**RE: Commercial & Apartment Building – Phase I  
4<sup>th</sup> St NW and Freeman Ave NW  
Grading and Drainage Plan  
Engineer’s Stamp Date 10-9-2015 (File: G14D066)**

Based upon the information received on 10-9-2015, the following items need to be addressed prior to Building Permit and Work Order (see comment #5) approval. Separate Grading and Paving permits are not typically required for small commercial developments.

**C4\_6**

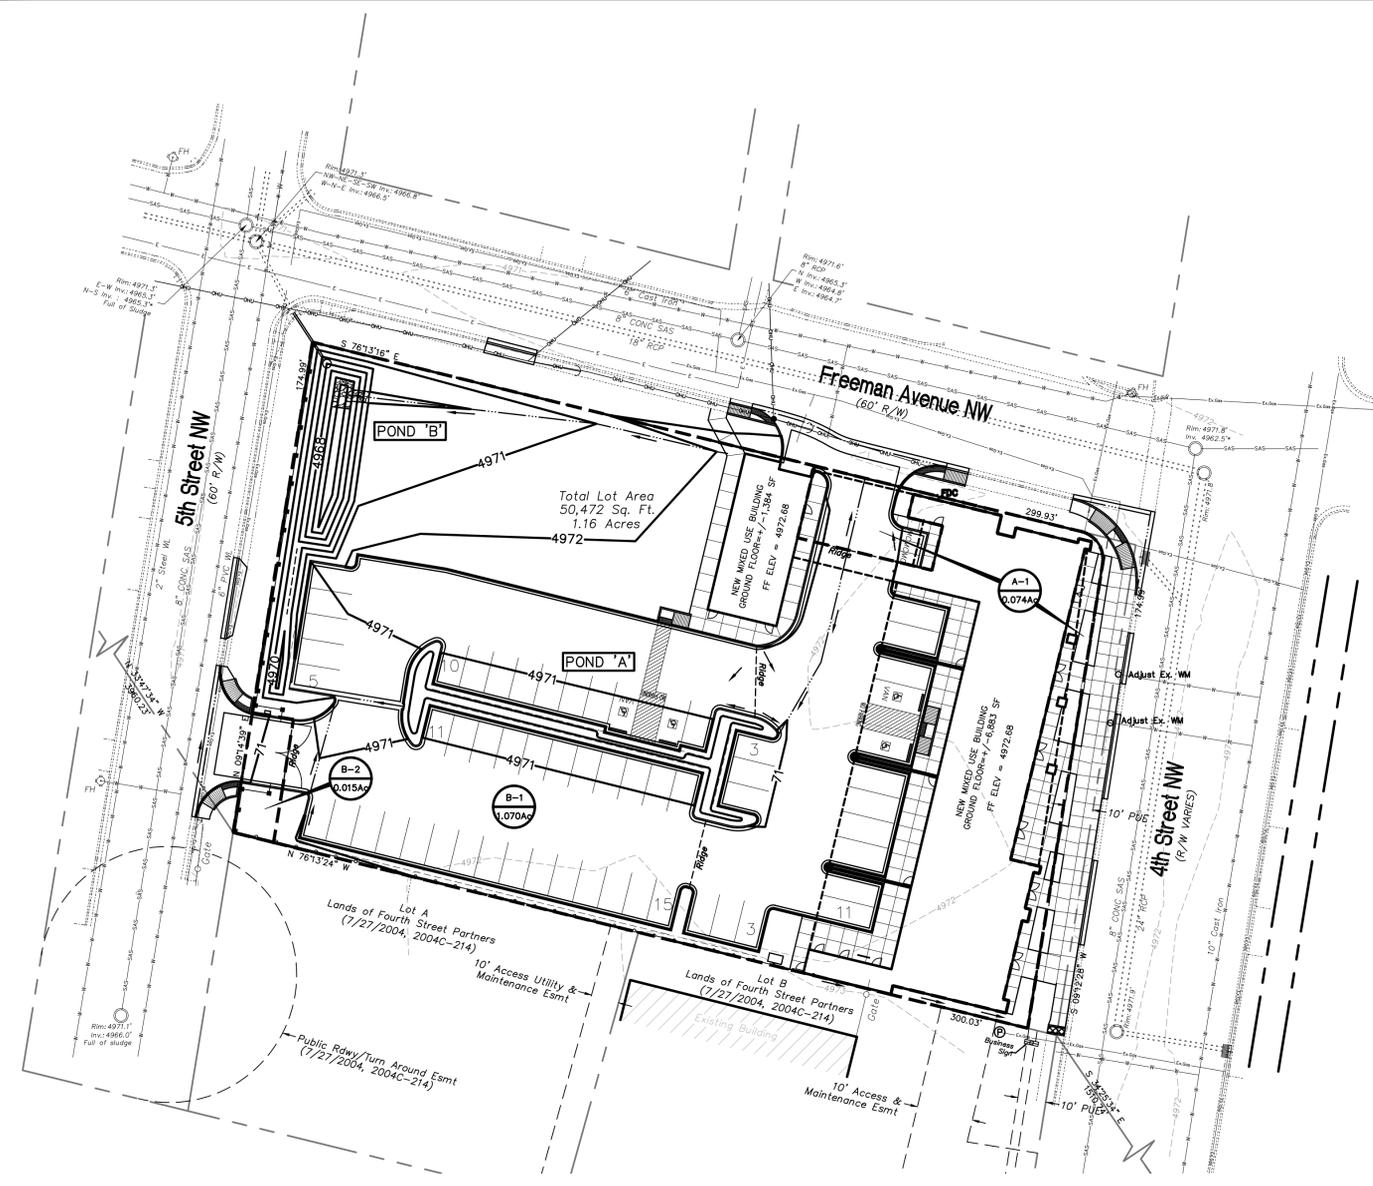
1. The drainage plan language on Sheet C4 states that this development will accept “any offsite flows from the south as needed”. It’s not clear how flows from the south would enter this project with the addition of curb along the southern edge. However, if flows *will* pass through this property, then they need to be quantified and accounted for to ensure the pond operates as intended (at least estimated, in the absence of a drainage report and detailed topographic information for the adjacent property).

- a. A private drainage easement will likely be necessary if flows are planned to pass through the property, it does not appear that one exists in the plat recently presented at DRB.

2. Pond ‘B’ needs to show an emergency spillway.
3. Call out the curb openings for both ponds, and the pond bottom elevation for Pond ‘A’.
4. A Work Order (not an SO-19) will need to be processed for the improvements to the City Right of Way. The Work Order will require a Floodplain Construction permit (NW corner of 5<sup>th</sup> and Freeman is in Zone AH).

5. Please include a detail of the pond outfall (the referenced "Quick Drain" can continue to just be referenced by product name/number).
6. 8" PVC is not allowed for the pipe outfall that extends into City Right of Way; instead, 12" High Performance Polypropylene Pipe may be used. The approval letter to ADS from the City Engineer and the Standard Trench Installation Detail are enclosed for reference.
7. Call out a flush transition from the sidewalk culvert surface to the existing surface at the SE corner of the project.
8. Be aware that this plan does not appear to have addressed comments from Transportation, such as minimum sidewalk widths and wheelchair ramp layouts, which will be required through the TCL review.
